SUNDRY NOTICES AND REPORTS ON WELLS

Carson #207S

Energen Resources plans to make the following changes to the Carson #207S well:

WELL LOCATION AND ACREAGE DEDICATION PLAT

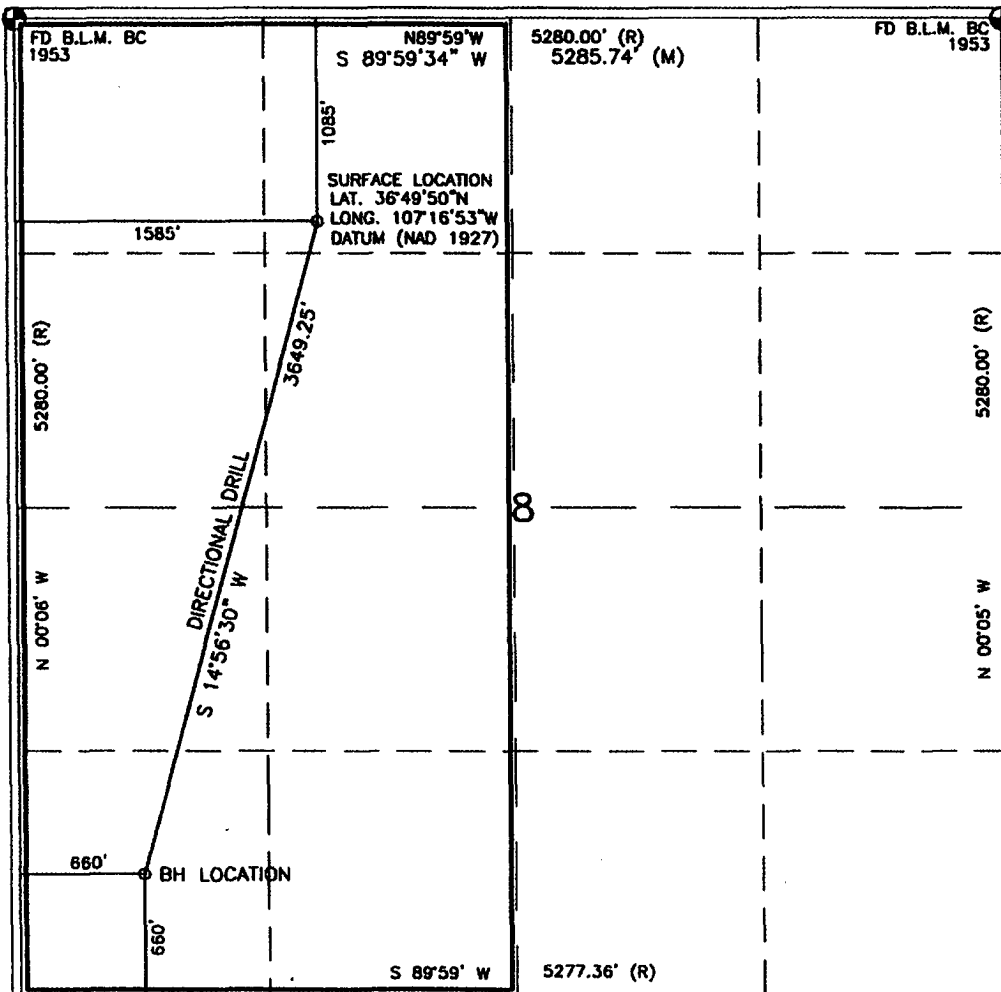
\* Change the drilling plan from a vertical completion to a horizontal drill plan and completion as indicated on the attached C-102 and directional survey plan.

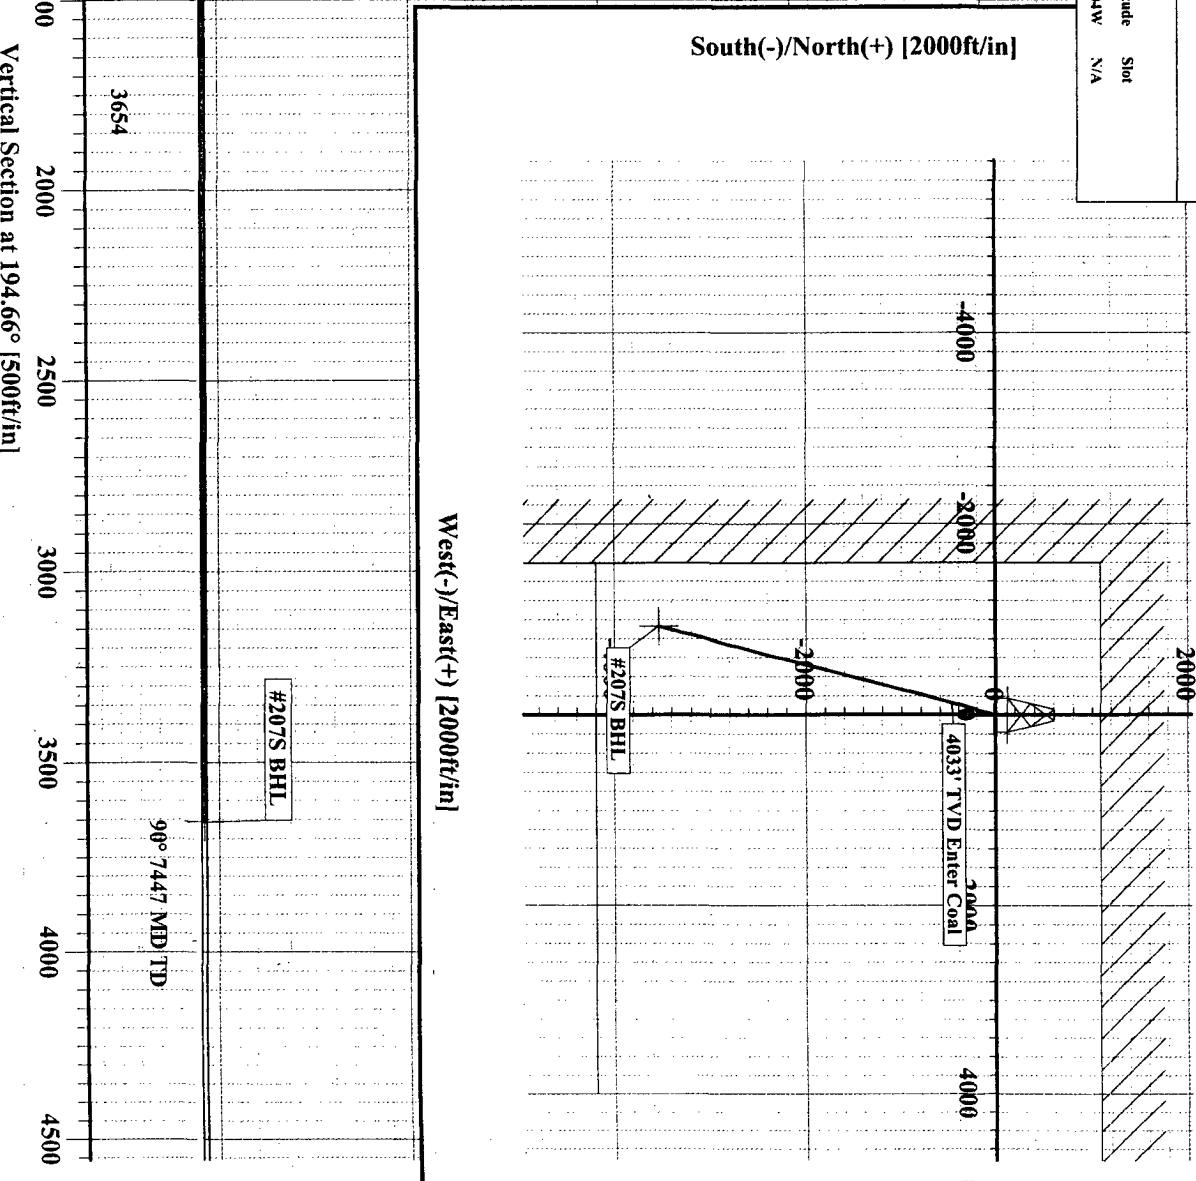
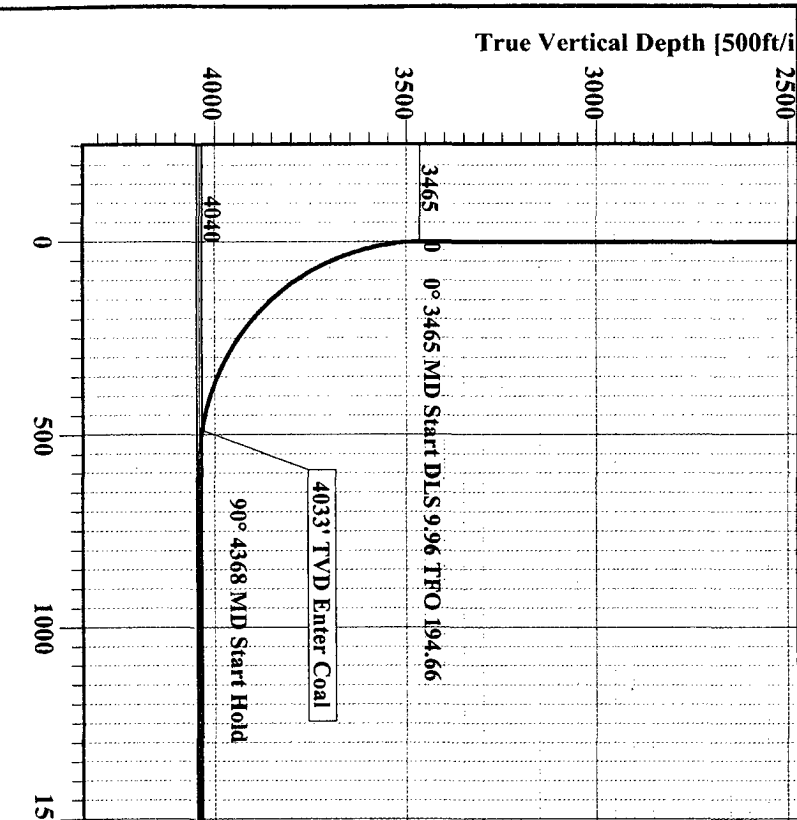
\* Change the setting depth of the 7" intermediate casing string from 3949' (TVD) to 4040' (TVD), 4445' (MD) and cement with 600 sks of lead followed by 125 sks of tail (1331 cu.ft.).

\* Change the 5-1/2" production liner to a 4-1/2", 11.6 ppf, J-55 LT&C production liner, and set to 4040' (TVD), 7447' (MD).
